VIRGIN ISLANDS WATER & POWER AUTHORITY

PR-03-27

Lead Service Line Inventory

ADDENDUM II

TYPICAL WATER SERVICE
CONNECTION TRENCH

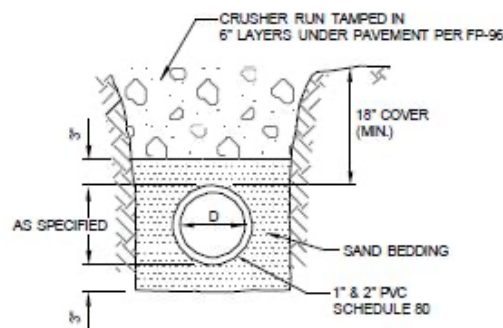
26. Does VIWAPA have an estimate of the number or percentage of locations involving asphalt, concrete, sidewalks, driveways, landscaping, unpaved surfaces, or other restoration types? Please provide the applicable Department of Public Works restoration details or standards the Offeror must use.

VIWAPA does not have an estimated breakdown of the surface conditions at the service locations. The Typical Water Service Connection Trench detail is provided below for general trench and backfill requirements. All disturbed areas shall be restored to their original using materials consistent with the existing surface, including concrete, asphalt, dirt, gravel, etc.
